ZONING CHANGE REVIEW SHEET

CASE: C814-2018-0121 -- 218 South Lamar

TO: PUD

ADDRESS: 218 South Lamar Boulevard Southbound

4-Lane Divided, 60' Curb-to-Curb
Back-of-Curb Condition F
Barton Springs Road to Riverside Drive

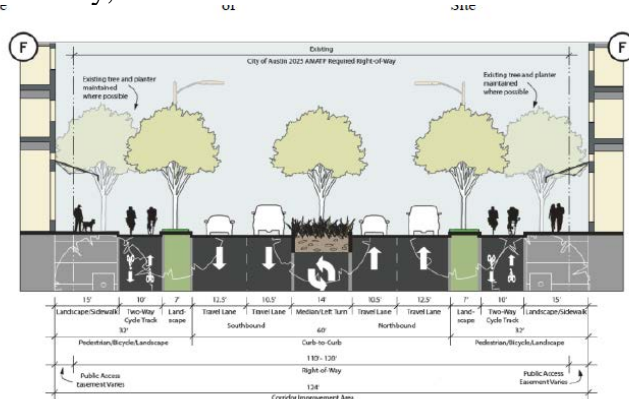
TR2. Include the below streetscape in the land use plan. Contact this reviewer for a more legible copy of it if necessary. This project is adjacent to a street that has been identified in Austin's Corridor Mobility Program (S Lamar). The sidewalk and bicycle facilities shall comply with the required cross-section at the time of the site plan application. The cross section that will be required is shown below. Find additional information about the Corridor Mobility Program here: <https://data.austintexas.gov/stories/s/Corridor-Mobility-Program/gukj-e8fh/>. Any proposed curb relocations on S Lamar requires coordination with the Corridor Planning Office and Bicycle Program. The cross section will include a 7' planting zone with street trees, a 10' two-way cycle track, and a 15' clear zone all behind curb. Additionally, a protected intersection will be required at Toomey, to be reviewed at the time of Site Plan.

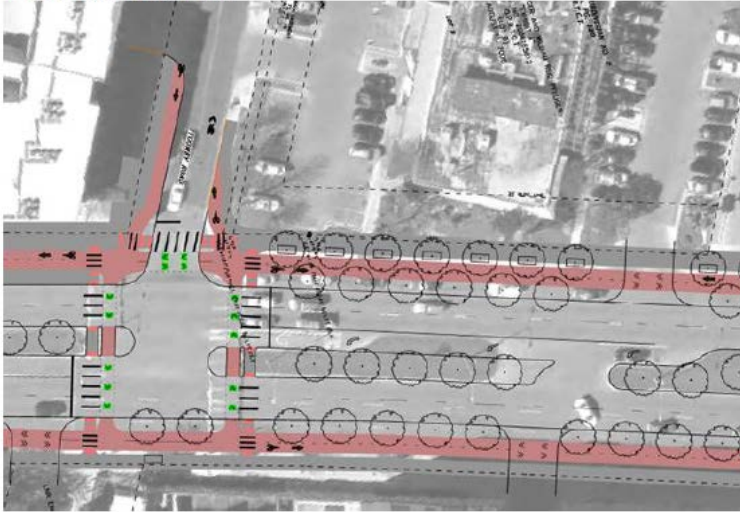
TR5. Bicycle facilities will be required along Toomey Road at the site plan stage. The design is below. Include the below graphic on the land use plan. If a more readable copy is required, contact this reviewer.
